APPLICATION NO.	FILING DATE	FIRST NAMED INVENTOR	ATTORNEY DOCKET NO.	CONFIRMATION NO.
10/711,289	09/08/2004	Robert G. Coulombe	GTAP:102US	5288

Office Action Summary	Application No. 10/711,289	Applicant(s) COULOMBE ET AL.	
	Examiner Marcus Menezes	Art Unit 3677

DETAILED ACTION

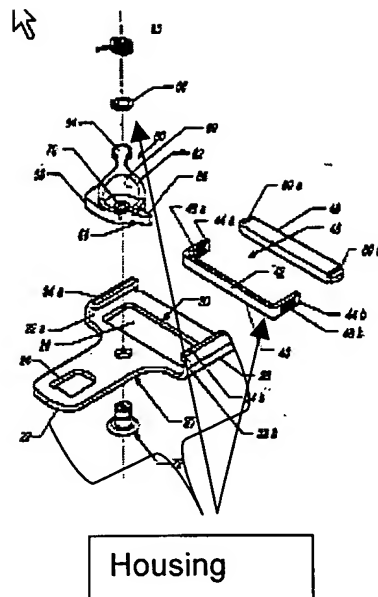
2. Claims 1-3 and 6-17 rejected under 35 U.S.C. 102(b) as being clearly anticipated by Ashline et al. (US Patent No. 5,649,341, hereinafter "Ashline").

Ashline discloses a quick release buckle comprising a first cam (62); a knurl bar (48); and a first spring (80) engaged with said first cam and said knurl bar. (See Fig. 1 below). Ashline further discloses that said first spring is operatively arranged to apply compressive force against said first cam and said knurl bar. (See Figs. 2-3 and col. 2, lines 60-67). Also, said knurl bar is operatively arranged to grip a belt (90) in response to said compressive force. Moreover, a housing with an integral mounting structure (72) is disclosed; and wherein said first cam is operatively arranged to rotate about said mounting structure and wherein said housing further comprises first (20) and second (65) components and said mounting structure is integral to said first component. (See figure below). Additionally, said mounting structure is integral with said second component, is extruded from said housing and is operatively arranged to engage said first and second components.

Furthermore, Ashline discloses that said housing has a first mounting structure that is a protrusion fixedly attached to said housing and where a first cam pivotally mounted on said first mounting structure is operatively arranged to rotate about said first mounting structure.
